## Report to the Joint Regional Planning Panel

<b>Application number</b>	DA-417/2014
<b>Site address</b>	10-14 Hall Street, Bondi Beach
<b>Proposal</b>	Demolition of existing buildings and construction of a seven storey mixed use (shop top housing) building comprising of two basement levels (18 car parking spaces, 22 bicycle spaces, 5 motor cycle spaces and garbage rooms), one commercial/retail shop, 20 serviced apartments and 21 residential units.
<b>Date of lodgement</b>	5 September 2015
<b>Owner</b>	G.J.D.Property Pty Limited
<b>Applicant</b>	Urbis Pty Ltd
<b>Submissions</b>	Thirty one
<b>Cost of works</b>	\$22,966,900 (DA estimated cost of proposal, including GST) \$20,879,000 (Capital Investment Value)
<b>Issues</b>	SEPP 65 principles, RFDC controls, zoning objectives, bulk and scale (height, FSR and setbacks), heritage conservation, building separation, views and view sharing, overshadowing, waste management, operations of serviced apartments, visual and acoustic impacts and public submissions

<b>Recommendation</b>	That the application be <b>REFUSED</b> .

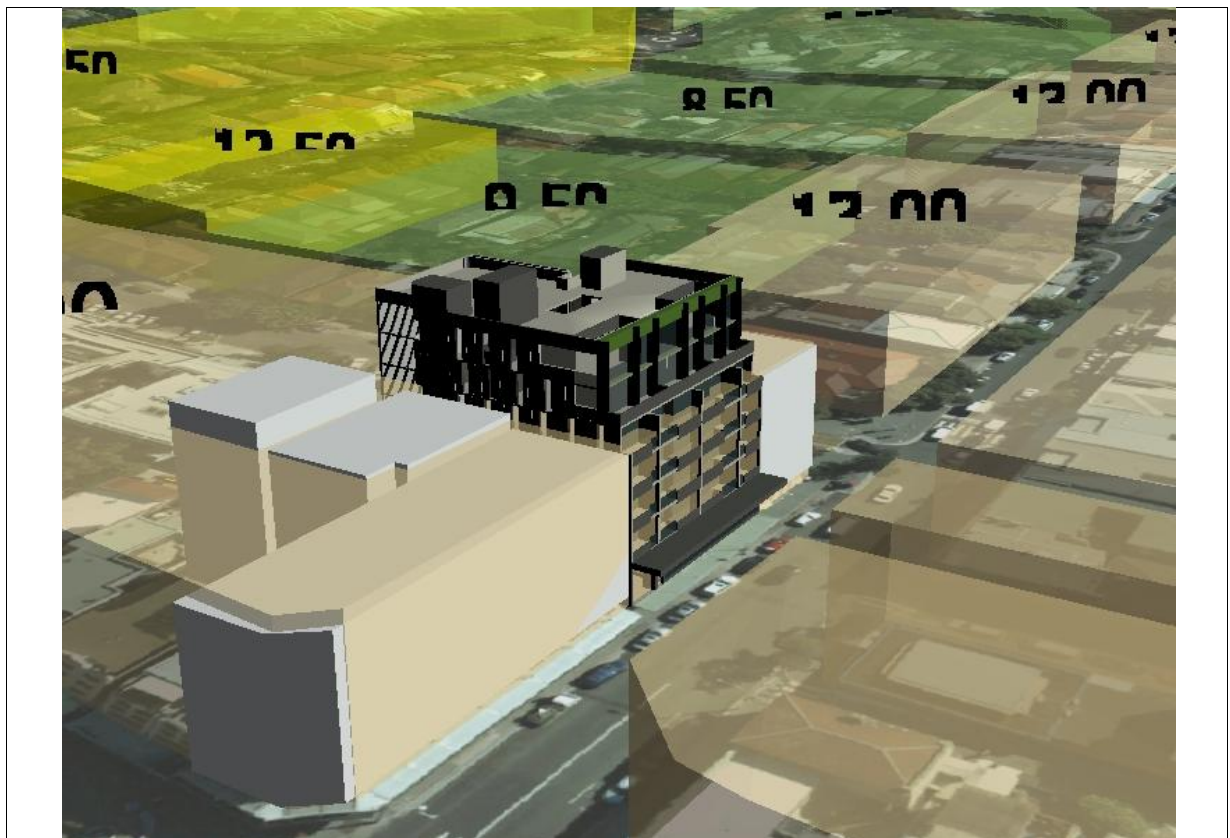
Height controls are subjective, as is the interpretation of bulk and scale; however the height control is a standard in Waverley LEP 2012, which has been through a statutory process involving exhibition and public comment. The height control reflects the preferences of the locality community and the height control should be given a deal of weight. As such the clause 4.6 exception is not considered to be well founded and the variation to the height control is not supported. The application is recommended for refusal.

The proposed height noncompliance has failed to address the provision of clause 4.6 (1)(b), (3)(a) and (b), and (4)(a). The proposed height noncompliance will result in an unacceptable development outcome for the site, fails to demonstrate that compliance with the development standards is unreasonable or unnecessary, does not establish sufficient environmental planning grounds to justify the breach, fails to address the objectives of the height development standard and in the public interest.

**Figure 7:** Winter solstice shadow analysis (DA025-REV), red circles highlight deficiencies of shadow diagrams.

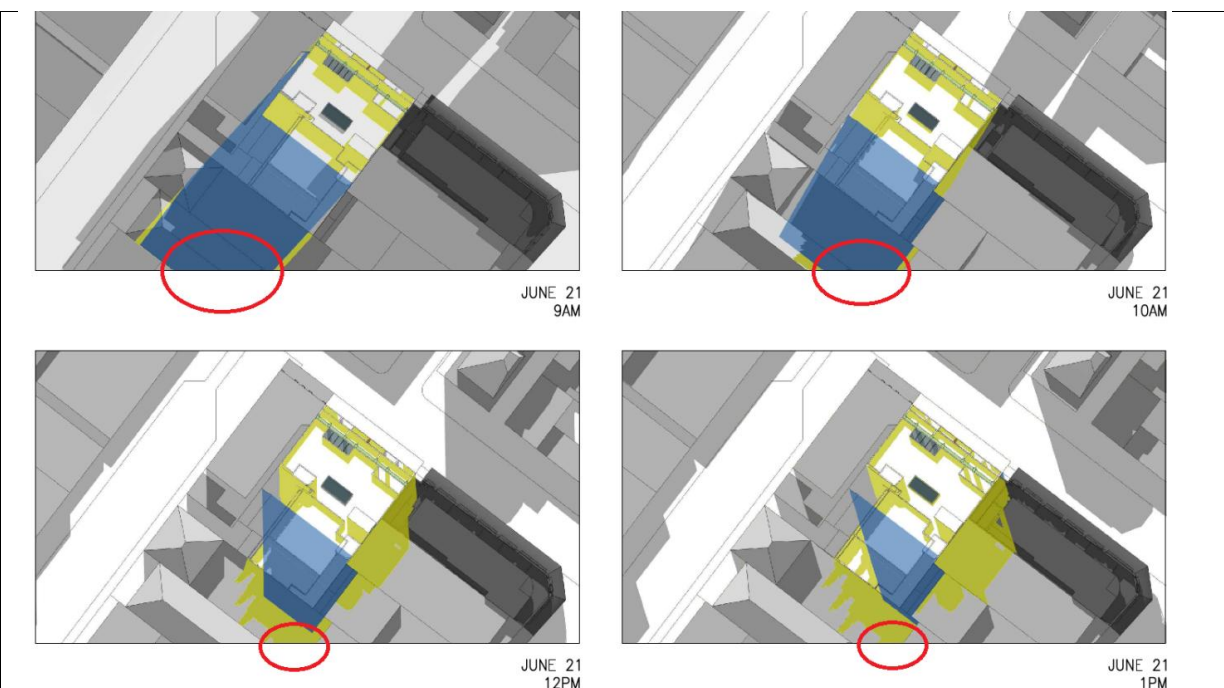
However, the documentation provided by the applicant is insufficient, whereby the shadow analysis diagrams appear incomplete, not depicting the full extent of shadow impacts on surrounding buildings and sites (see Figure 7 below) and no elevation shadow diagrams have been submitted. In this regard, compliance with the relevant controls has not been adequately addressed, and as there will be increased overshadowing that could be otherwise avoided with a compliant building form, the proposal is not supported.

- Shadow analysis diagrams are incomplete failing to allow for assessment of the full extent of shadowing impacts on surrounding buildings and allotments.
- Inconsistencies exist between the architectural drawings, photomontage and landscape concept plans.

**Figure 8:** Heritage map extract from the WLEP 2012.

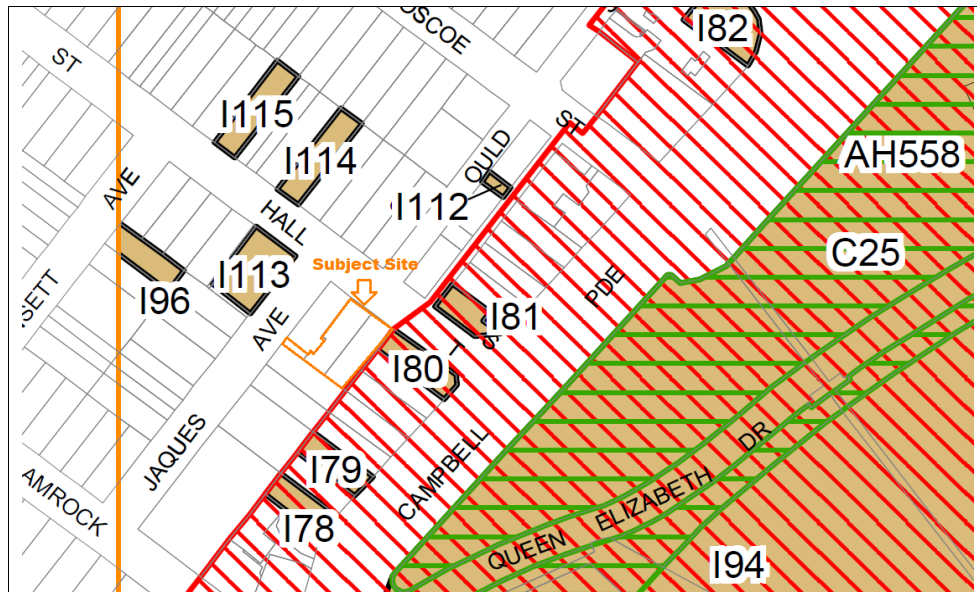
The subject site adjoins and is located in the vicinity of a number of heritage items and heritage conservation areas identified in Schedule 5 – Environmental Heritage of the WLEP 2012 (see Figure 8 below).
